VIRGINIA ELECTRIC AND POWER COMPANY
SURRY POWER STATION UNITS 1 AND 2
GENERIC LETTER 87-02 – UNRESOLVED SAFETY ISSUE (USI) A-46
REQUEST FOR ADDITIONAL INFORMATION

RESPONSE TO NRC RAI RE UNRESOLVED SAFETY
ISSUE (USI) A-46

Surry Power Station Units 1 and 2

RESPONSE TO REQUEST FOR ADDITIONAL INFORMATION GENERIC LETTER 87-02 SURRY POWER STATION UNITS 1 AND 2

In-Structure Response Spectrum (ISRS) - Design Basis Earthquake Turbine Building - Elev. 64' - Horizontal Direction - 5% Spectral Damping SURRY POWER STATION UNITS 1 AND 2

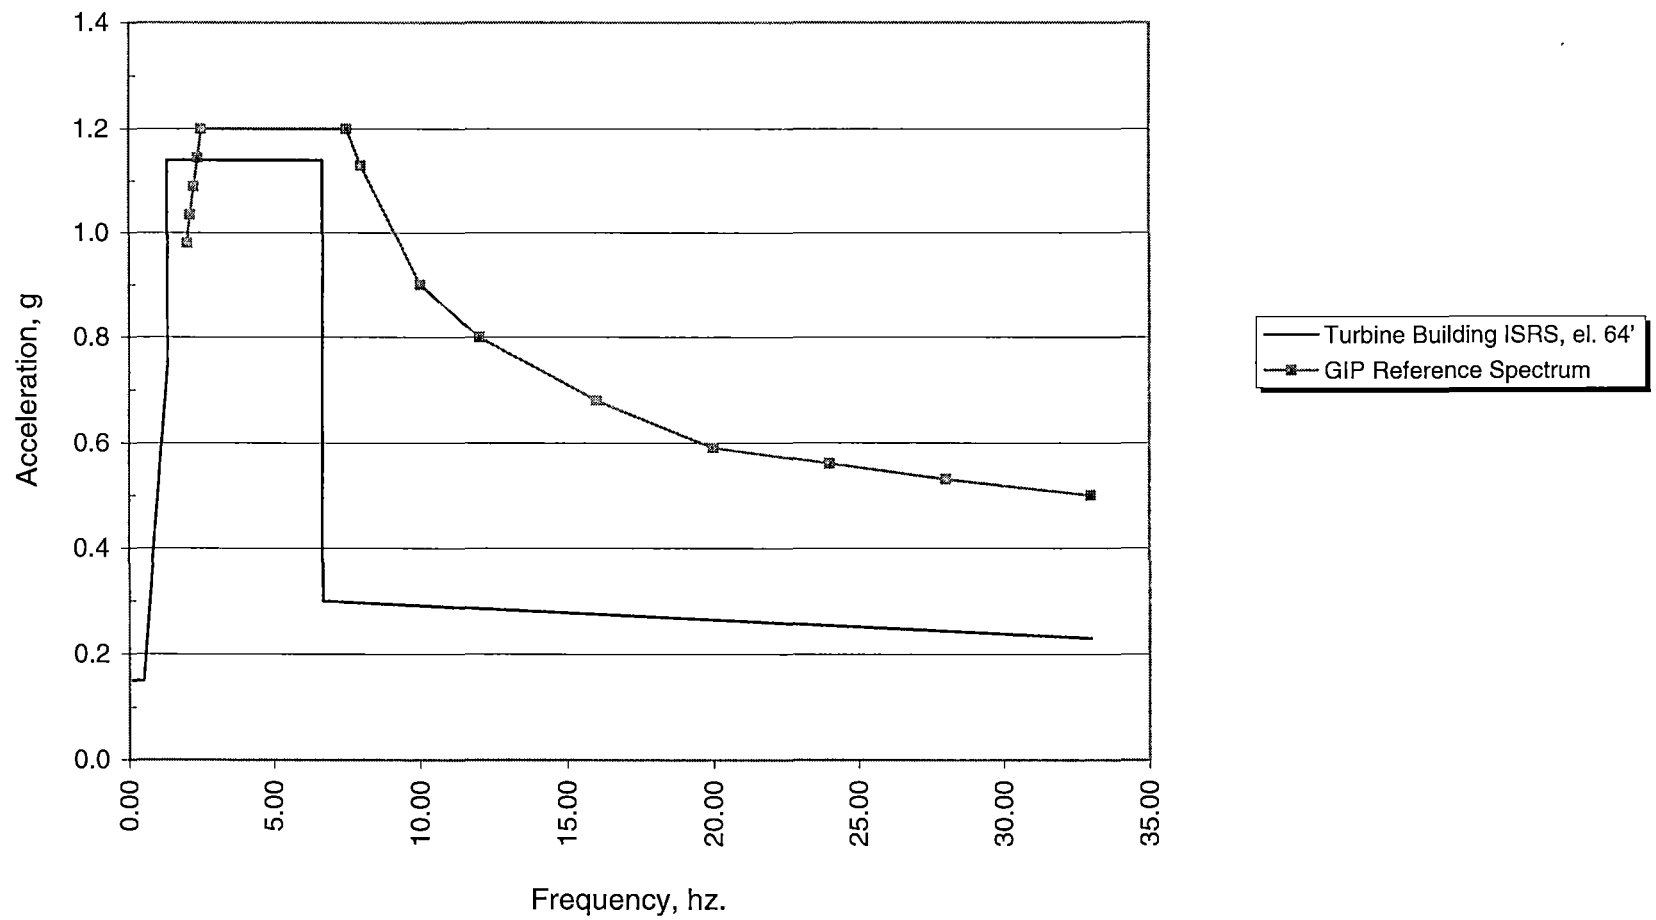
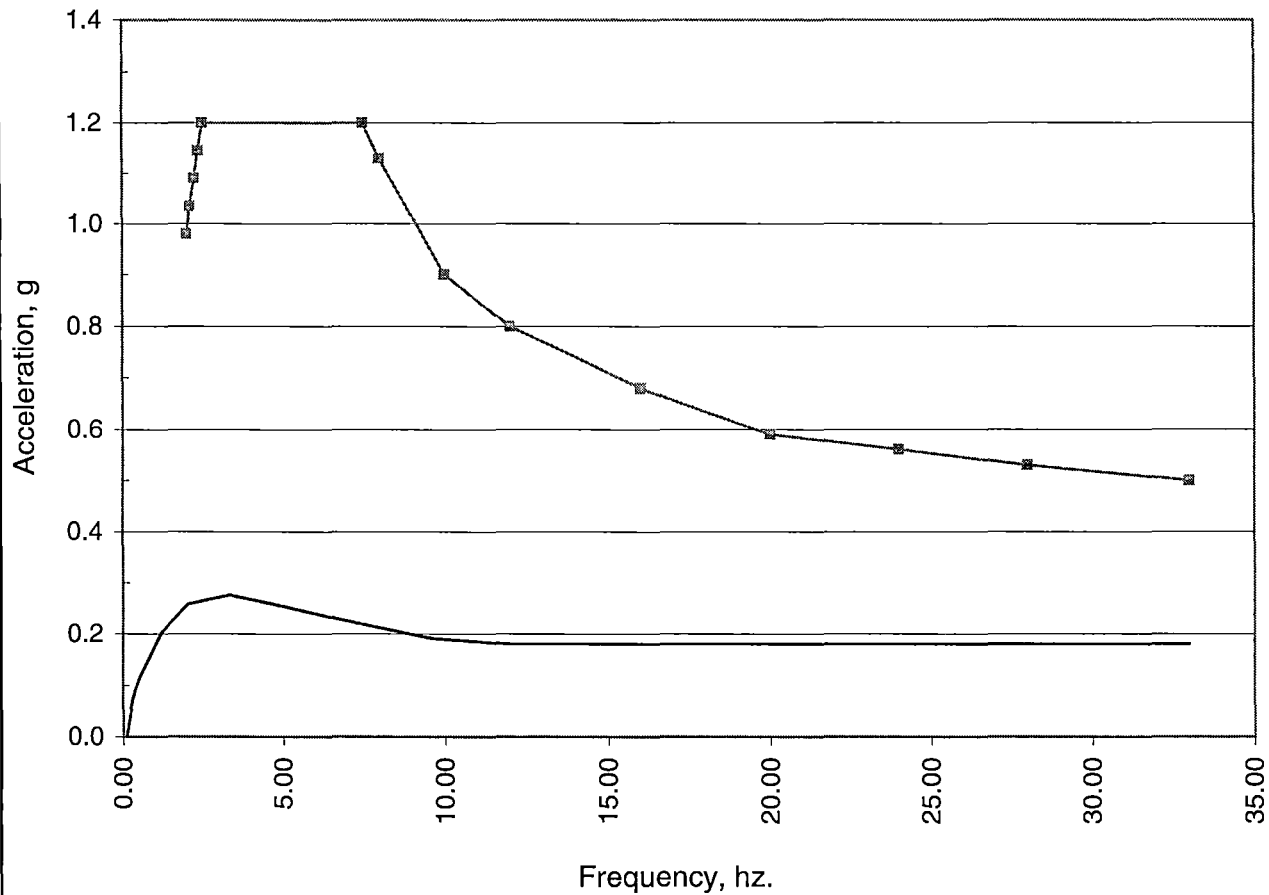
It is stated in the referenced submittal that for all buildings and elevations where (SSEL) equipment is located in the Surry plant, the in-structure response spectra (ISRS) are enveloped by the Reference Spectrum or the 1.5 x Bounding Spectrum of the GIP. You are requested to provide the ISRS at the highest elevations where SSEL equipment items are located in each building, and demonstrate their enveloping by the Reference Spectrum.

Comparisons of ISRS (envelope of both horizontal directions) at 5% spectral damping at the above locations and the 1.5 x Bounding Spectrum (Reference Spectrum) of the GIP are provided in Enclosure 2. This comparison demonstrates that the Reference Spectrum completely envelops the ISRS or meets the intent.

¹ Enveloping of ISRS of both the internal and the external structures is provided at this elevation.

² Peaks are extrapolated from 1% damping ISRS to obtain 5% damping ISRS for comparison with the Reference Spectrum. A few valves are located at elev. 62', and a slight excursion near 2 hz. is judged to meet the intent of GIP.

³ The Emergency Diesel Generator Rooms are included in the model for the Service Building. It is also noted that the Reactor Trip Breakers are located in this building at elevation 45' within a compact structural hut. Although they are top braced to the hut at elevation 54', the ISRS at elevation 45' was judged to be applicable. This is the highest elevation in this building containing any SSEL equipment item.

⁴ No new analysis was done for the Turbine Building to generate ISRS. The conservative, design ISRS at all elevations in this building is based on the Taft earthquake input and was developed in the 1971 time frame for 1% spectral damping. From this, ISRS at 5% spectral damping was recently developed, and is compared with the 5% damped Reference Spectrum of the GIP. A slight exceedance near 2 hz is judged to meet the intent of the GIP.

⁵ No Housner basis design ISRS was developed for this structure. A study concluded that the ISRS is not larger than 1.2 times the ground spectrum at the highest elevation where SSEL components are located in this building.

⁶ This is a compact structure, and SSEL components are located below the grade level. Therefore, the ISRS is judged to be less than 1.2 times the ground response spectrum.

USI A-46 Evaluation of Charging Pump Seal Cooling Surge Tanks (1-CC-TK-3, 2-CC-TK-3):

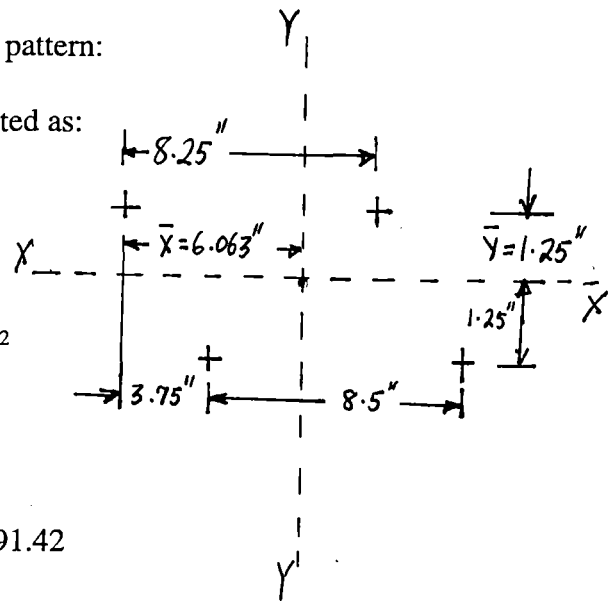
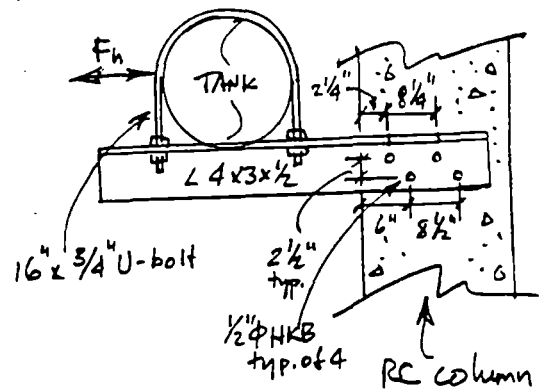
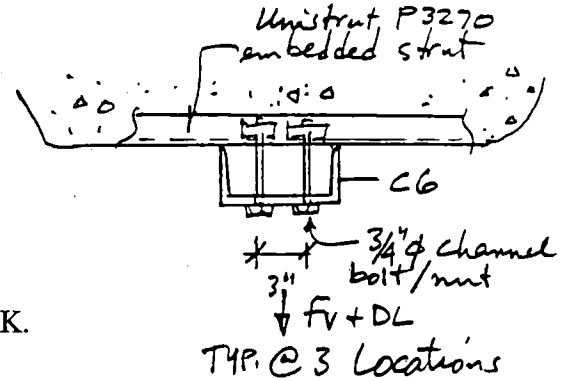
In reference to item No. 1, you are requested to verify the seismic adequacy of the charging pump seal cooling tanks and refueling water storage tanks by performing a deterministic analysis, in accordance with the GIP-2 methodology, and submit the analysis results for staff review.

The charging pump seal cooling surge tanks (1/2-CC-TK-3) are suspended tanks. Each tank is fabricated from 16" outer diameter, schedule 10 pipe and is about four feet in length. A previously performed calculation for the IPEEE (seismic) program showed that its High-Confidence-of-Low-Probability-of-Failure (HCLPF) capacity was much greater than 0.3g, expressed in terms of peak ground acceleration (pga). As requested by the staff, this calculation has been revised. The revision, which was performed in accordance with the deterministic USI A-46 methodology of the GIP, is provided as Enclosure 3. It demonstrates that the tank anchorage has substantial capacity to withstand the design basis earthquake loads based on the USI A-46 approved in-structure response spectra and the GIP-2 methodology.

Conclusion: Based on the above, the tank anchorage has adequate margin for USI A-46.
